# Recall Bulletin 180618REV

Fleetwood Flair and Holiday Rambler Admiral, Model 28 A only, manufactured April 26, 2018 through June 1, 2018

**SUBJECT:**  
Inspection / Correction of Wire Harness Routing for Nightstand 120-Volt Receptacle

**ISSUE DATE:**  
July 2018

Figure 1

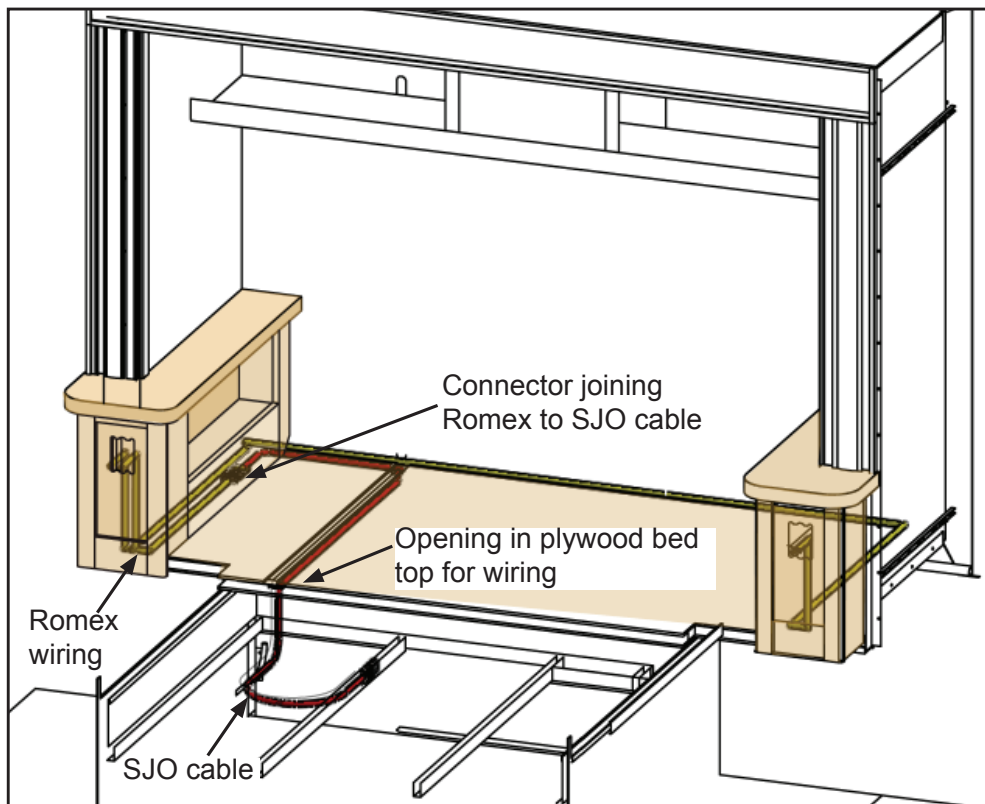
On certain Admiral and Flair model 28 A motorhomes affected by this recall, the 120-Volt wire harness for a nightstand receptacle in the bedroom was not routed properly. Non-flexible Romex wiring was erroneously routed from the stationary bed base to the nightstand receptacle instead of the required flexible-sheathed SJO cable.

The Romex may become damaged as a result of extending and retracting the slide-out. If the Romex wiring is damaged, an electrical short could result, posing the risk of fire which may result in property damage, injury, or death.

6. Carefully loosen and remove the top from the rear bedroom nightstand by pulling it straight out, away from the wall. Set this component aside for reassembly.  
Note: The nightstand top is not fastened with nails, but it may need to be tugged hard in several places to free it from molding and/or caulk.
7. Remove the screws fastening the rear nightstand base to the wall, allowing it to be moved as needed during repairs. Retain screws for reinstallation.
8. Disconnect the Romex from the rear nightstand's 120-Volt receptacle, and then remove the 120-Volt receptacle from the nightstand. Set the receptacle aside for reassembly.

Route the wire harness up and through the nightstand, until the connector between the Romex wiring and the SJO cable comes out through the opening in the plywood bed top. Continue to tug on the wire harness until the connector between the Romex and SJO cable is located inside the false bottom of the nightstand. The excess Romex should extend through the receptacle opening in the nightstand, until it is trimmed in the next step.

11. Use wire cutters to shorten the Romex, removing the slack that was created when performing Steps 8-9. Strip 3/4" of jacket insulation from the Romex wires, and then reconnect the Romex to the receptacle.

12. Use nylon wire ties or insulated loop clamps to secure the Romex and the SJO cable every 12" inside the false bottom of the nightstand. The Romex must be secured within 12" of the 120-Volt receptacle.

13. Reinstall the 120-Volt receptacle and fasten it into position.
14. Ensure the SJO cable exits the false bottom of the nightstand through the notch in the nightstand framing.

**Figure 2**

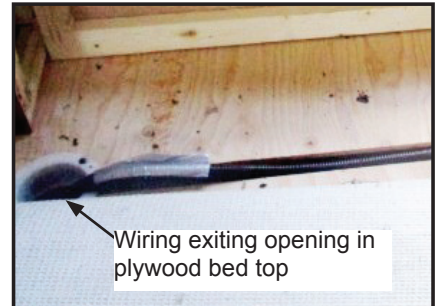
9. Peel the corner of the carpet away from the rear, inboard corner of the plywood bed top, until the opening for the wiring is exposed. See Figure 2.

10. Gently tug on the wire harness, pulling the wiring up out of the opening. Feed the unattached end of the Romex wiring out through the receptacle opening in the nightstand.
